DART SERVICE INSTRUCTION

TO AMEND INSTALLATION INSTRUCTIONS IIN-D130-701 REV. D OR EARLIER
AND INSTRUCTIONS FOR CONTINUED AIRWORTHINESS ICA-D130-701 REV. 1 OR EARLIER

REF. TCCA STC: SH94-14
REF. FAA STC: SR00213NY
REF. EASA STC: 100016996

FIGURE 1: TOP FWD EDGE RELIEF ON D4037-3 FWD CHANNEL

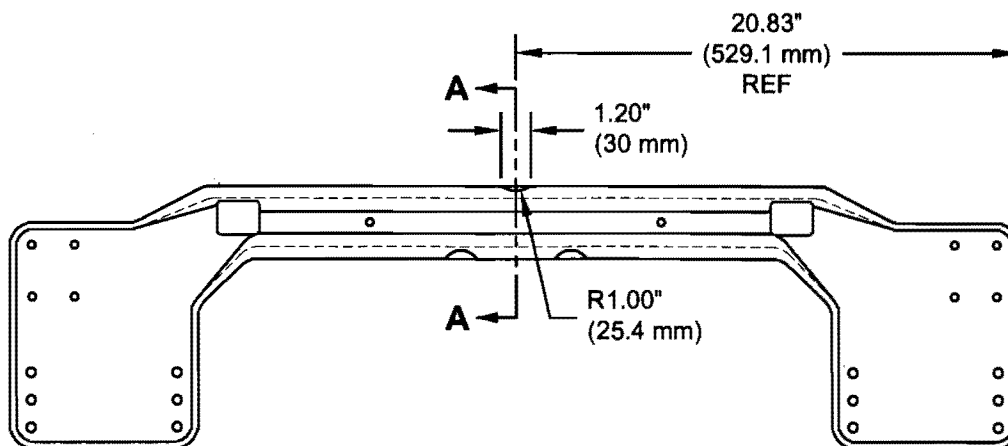
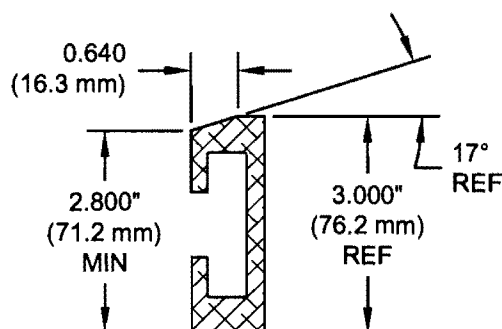
Customers with D130-701-043 Heli-Utility Basket, D130-701-011 Conversion Kit, and D130-701-013 Fixed Provision Kit at CHG 004 or earlier may experience interference with fuel tank panel when installing D4037-3 Fwd Channel. To resolve this interference issue, it is acceptable to trim the top fwd edge of D4037-3 Fwd Channel per Section 2.0 below.

2.0 RELIEVING TOP FWD EDGE OF D4037-3 FWD CHANNEL:

- 2.0.1 Locate and trim area to be relieved per Figure 1 of these instructions;
- 2.0.2 Touch up re-worked area per Section 5.1.4 of ICA-D130-701;
- 2.0.3 Install re-worked D4037-3 per Section 25.4 of ICA-D130-701 (or Section 3.2 of IIN-D130-701).

FIGURE 2: TRIMMING D4038-041/-042/-043/-044 (AS APPLICABLE)
(D4038-041 SHOWN, D4038-043 SIMILAR, D4038-042/-044 OPPOSITE)

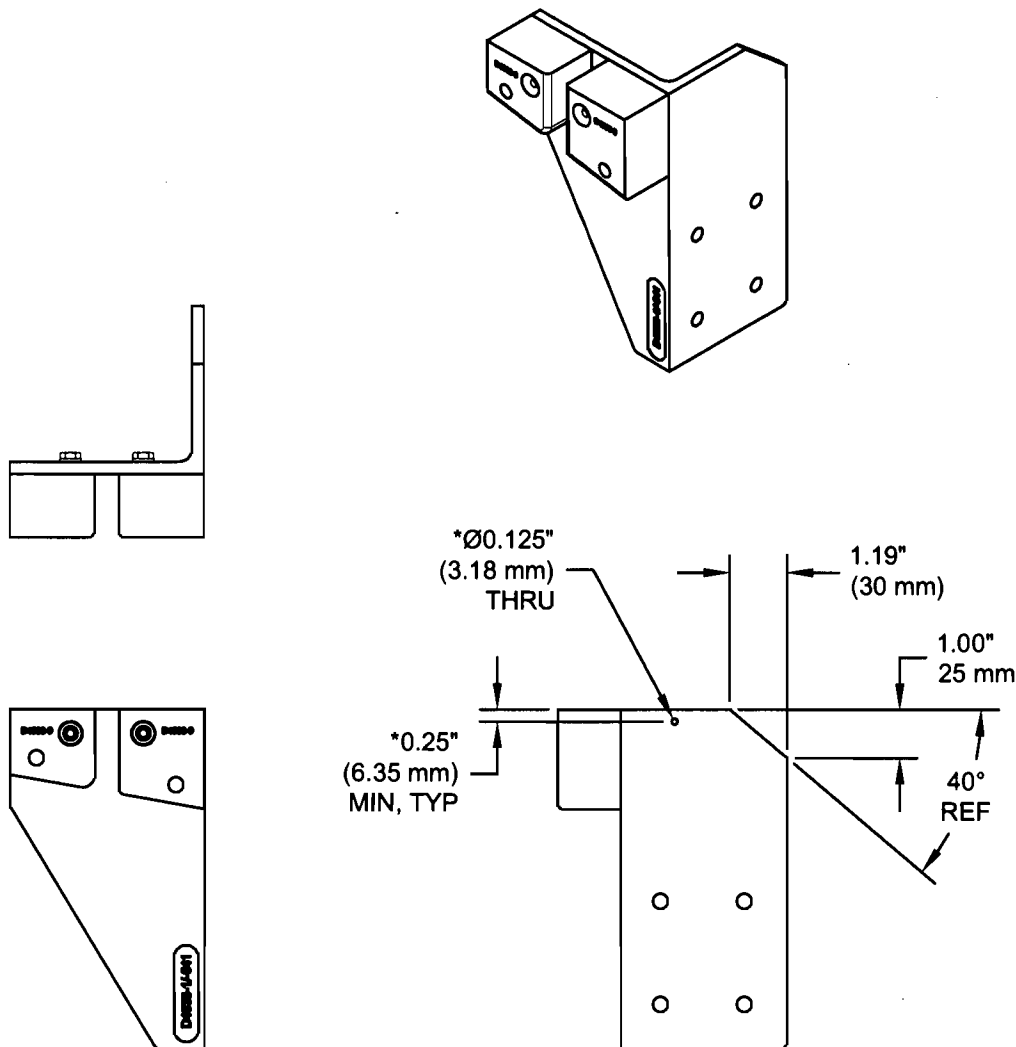
Customers with D130-701-043 Heli-Utility Basket, D130-701-011 Conversion Kit, and D130-701-013 Fixed Provision Kit at CHG 004 or earlier who wish to ensure compatibility with other kits may relieve the D4038-041/-042/-043/-044 (as applicable) per Section 3.0 below.

Customers operating D130-701-043 Heli-Utility-Basket simultaneously with cargo hook may route the manual cargo release through D4038-041/-042/-043/-044 (as applicable) as shown in Figure 3 of these instructions. Although DART approves drilling of the Ø0.125" (3.18 mm) hole into the D4038-041 Bracket, it is up to the customer to ensure proper operation of the cargo hook manual release and ensure this will not cause the cable to snag during operation.

3.0 TRIMMING D4038-041/-042/-043/-044 (AS APPLICABLE):

4.0 COMPATIBILITY WITH MANUAL CARGO RELEASE:

- 3.0.1 Locate and trim D4038-041/-042/-043/-044 (as applicable) per Figure 2 of these instructions;
- 3.0.2 Touch up re-worked area per Section 5.1.4 of ICA-D130-701;
- 3.0.3 Install re-worked D4038-041/-042/-043/-044 (as applicable) per Section 25.4 of ICA-D130-701 (or Section 3.2 of IIN-D130-701).

- 4.0.1 Locate and drill Ø0.125" (3.18 mm) hole through D4038-041/-042/-043/-044 (as applicable) per Figure 2 of these instructions (ref dimensions marked "**");
- 4.0.2 Touch up re-worked area per Section 5.1.4 of ICA-D130-701;
- 4.0.3 Install re-worked D4038-041/-042/-043/-044 (as applicable) per Section 25.4 of ICA-D130-701 (or Section 3.2 of IIN-D130-701).

*: HOLE ONLY REQUIRED TO ROUTE MANUAL CARGO RELEASE CABLE.
APPROX LOCATION SHOWN WITH MINIMUM PERMISSIBLE EDGE DISTANCE.
